AN ORDINANCE approving the Heights Water Association
Comprehensive Water System Plan.

The King County Utilities Technical Review Committee (UTRC) reviewed and conditionally approved the Plan on June 17, 1998. The conditions of approval (technical modifications to the Plan) have been met by the association.

1997 COMPREHENSIVE WATER SYSTEM PLAN
HEIGHTS WATER
May 7, 1998

FIGURE 9

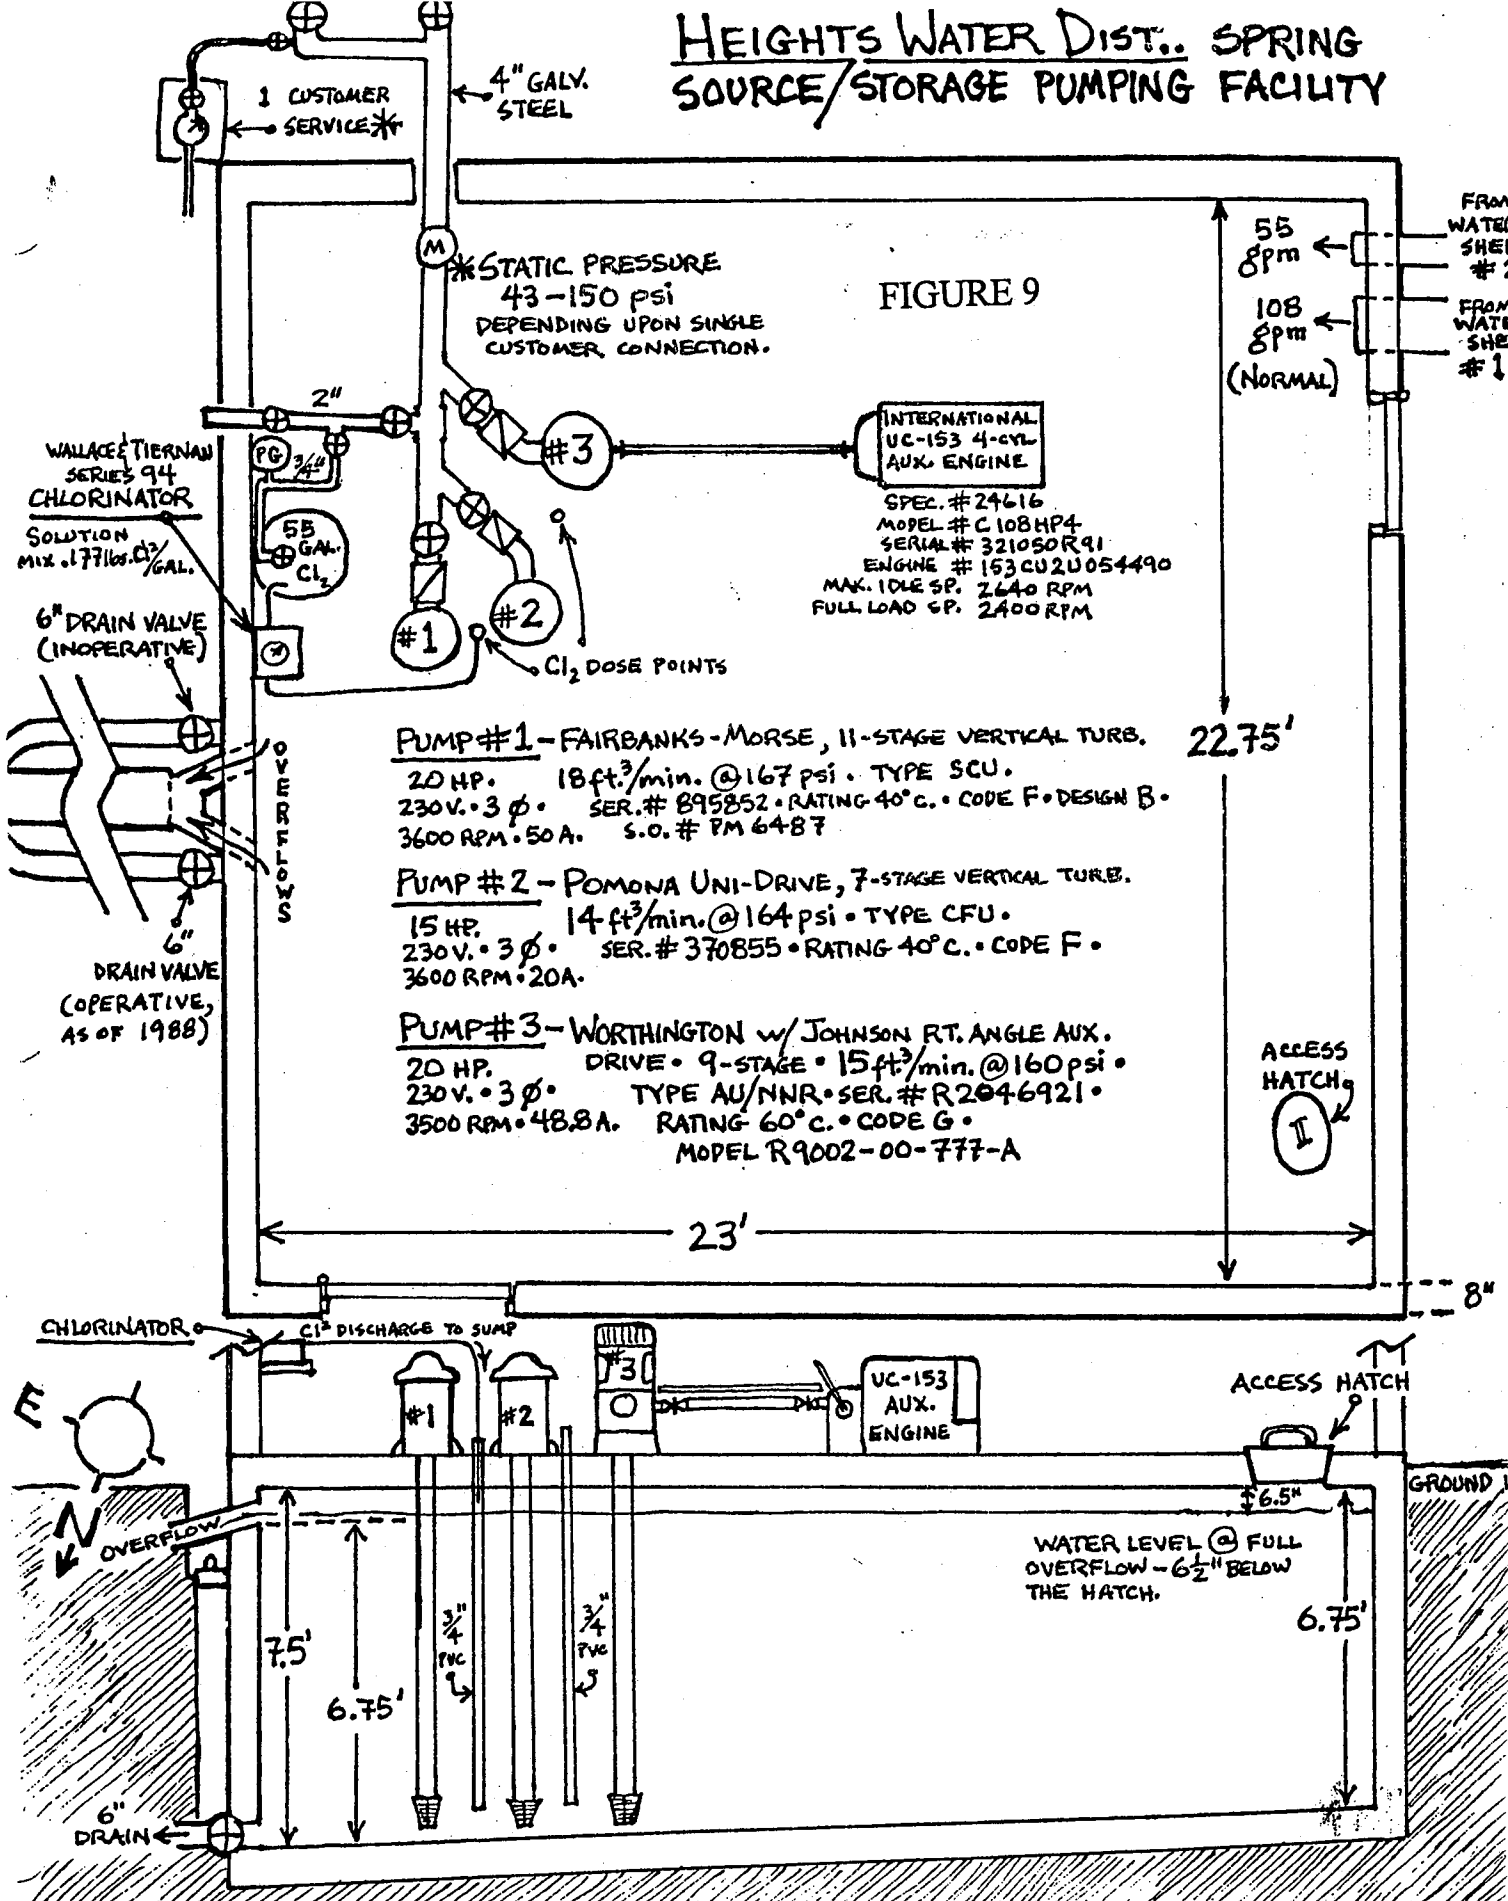
8. Page 3-3 indicates that the source clearwell pumping capacity is 184 gpm while page 3-4 could suggest that all three pumps could potentially produce as much as 352 gpm. Figure 9 identifies several pumping scenarios which exceed 184 gpm. Please clarify.

8. In fact, all three listed pumping scenarios exceed 184 gpm and were shown only as possibilities. These scenarios have been removed from Figure 9, since the system does not actually operate in this manner.
